**Planning Department
Transportation Development Services**

**Re: HLP Endodontics
10429 Lagrima De Oro NE
Traffic Circulation Layout**
Engineer's/Architect's Stamp dated 4-23-15 (F21-D063)

Based upon the information provided in your submittal received 4-28-15, the above referenced plan cannot be approved for Building Permit until the following comments are addressed:

11 | **enlarged entry plan**

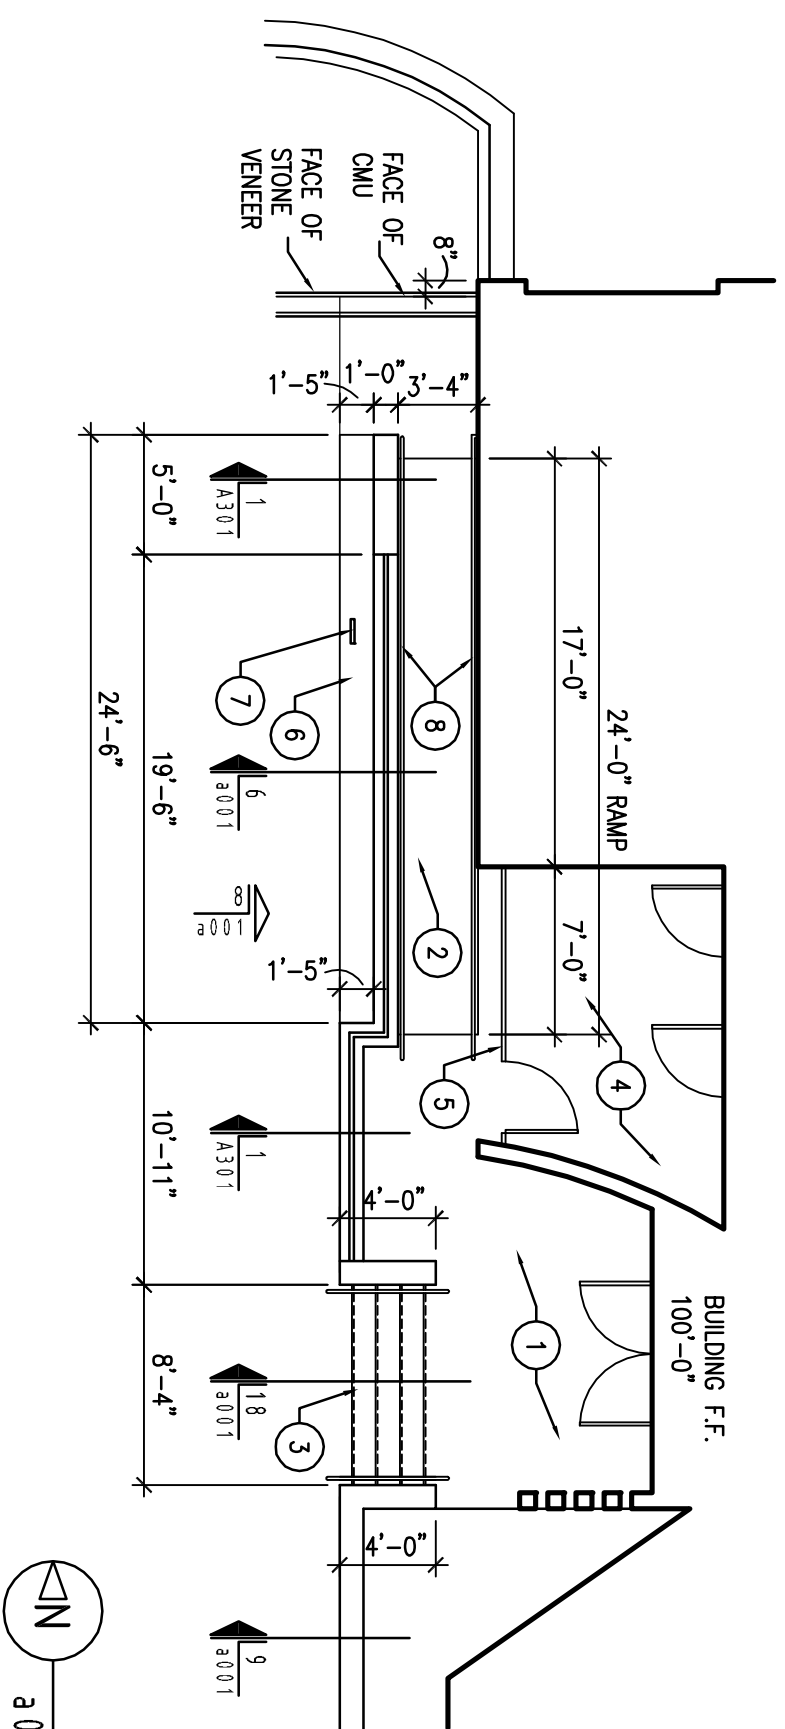
9. Per the DPM, a 6 ft. wide ADA accessible pedestrian pathway is required from the HC parking stall access aisles to the building entrances. The Handicap pathway must be a continuous 6 ft. wide. As detailed on your drawing, the handicap pathway narrows to 3 ft. 4 inches. Please design so that a 6 ft. wide pathway is provided for ADA accessibility into the proposed building.
10. Design delivery vehicle route needs to be shown.
11. Please provide a sight distance exhibit (see the *Development Process Manual, Chapter 23, Section 3, Part D.5 Intersection Sight Distance*). A Mini-Clear Sight Triangle needs to be maintained starting at the sidewalk and measuring 11 ft. on a side, as shown below.

17 | **hcp parking sign**

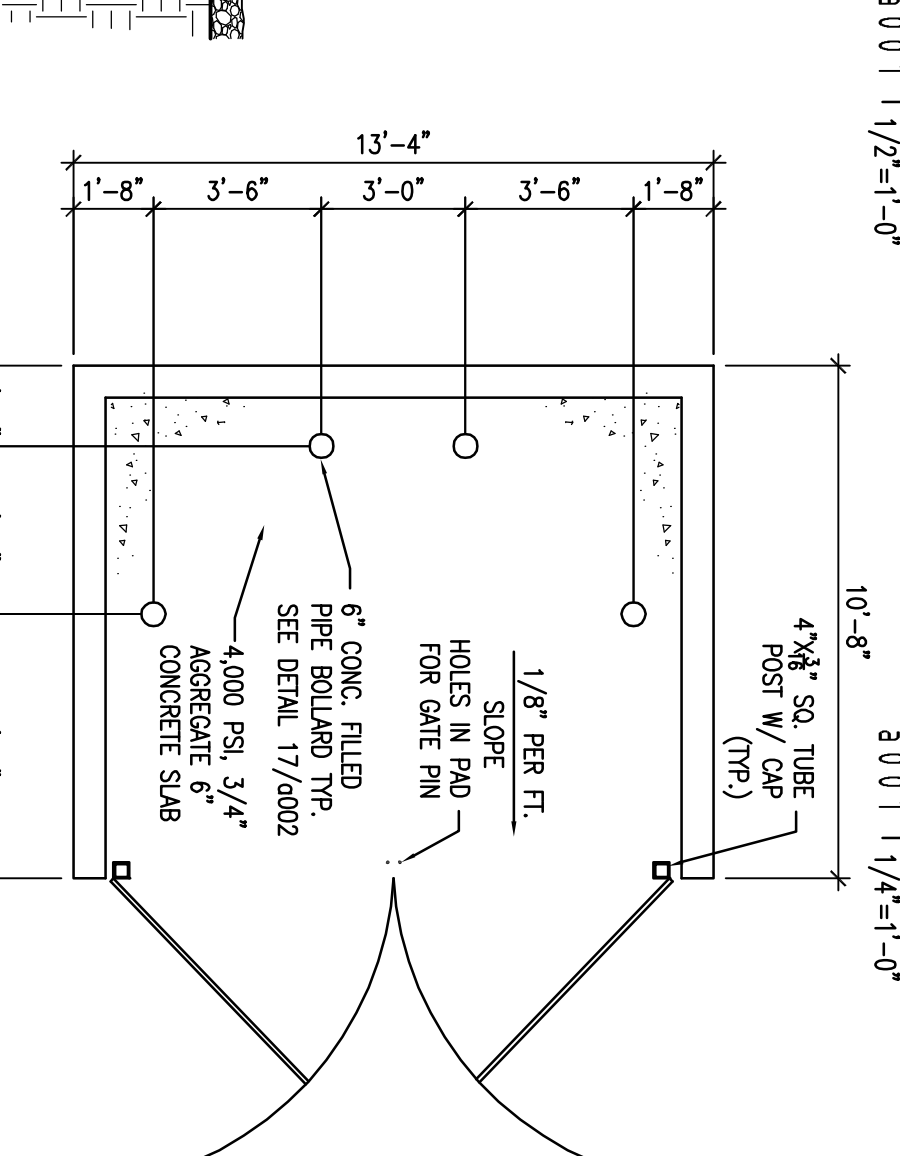
4. Clearly show the location of the motorcycle parking.
5. The ADA van accessible sign must have the required language per 66-7-352.4C NMSA 1978 **"Violators Are Subject to a Fine and/or Towing."**
